**Re: PA23-015 – MSR Tuscany Woods Townhomes – Technical Review 2**

After preliminary review of the above referenced proposal, the Planning Division has the following comments:

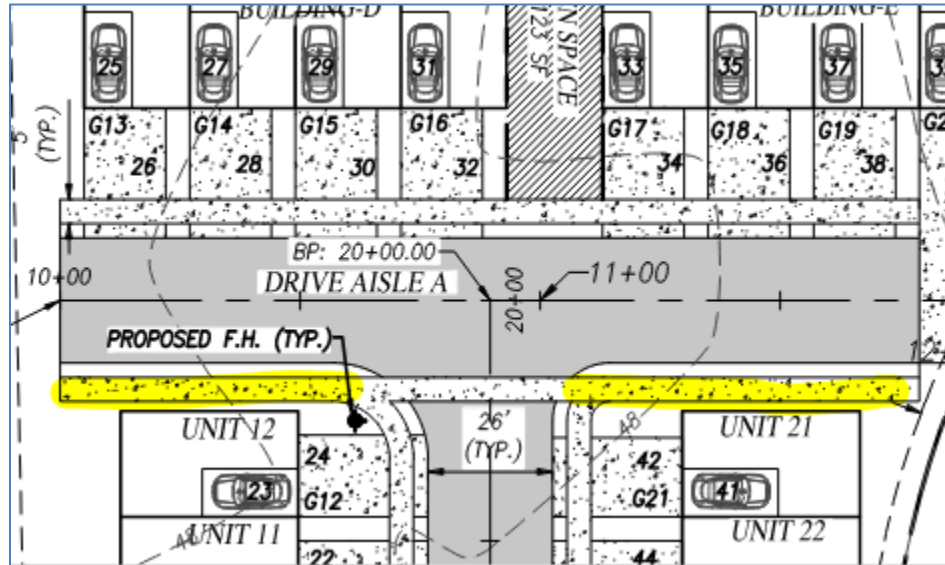
1. What is proposed for the portion of the private road (44<sup>th</sup> Drive NE) that is on the project property? Prior to further review, please identify how this area will be addressed. Is a Boundary Line Adjustment proposed? Whatever is proposed will likely impact allowable density, setbacks, etc.

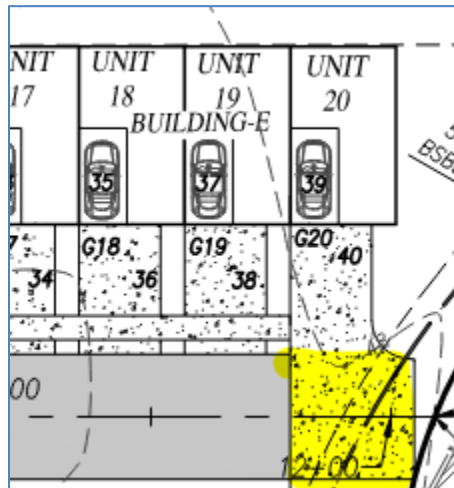
- The sidewalks on the south portion of Drive Aisle A effectively lead to nowhere and should be removed (see areas highlighted below).

- There is a portion of pavement that appears to be the proposed access for unit 20 that is shown in the private road (see area highlighted below). This is not acceptable and will need to be revised. No access from 44<sup>th</sup> Drive is permitted.
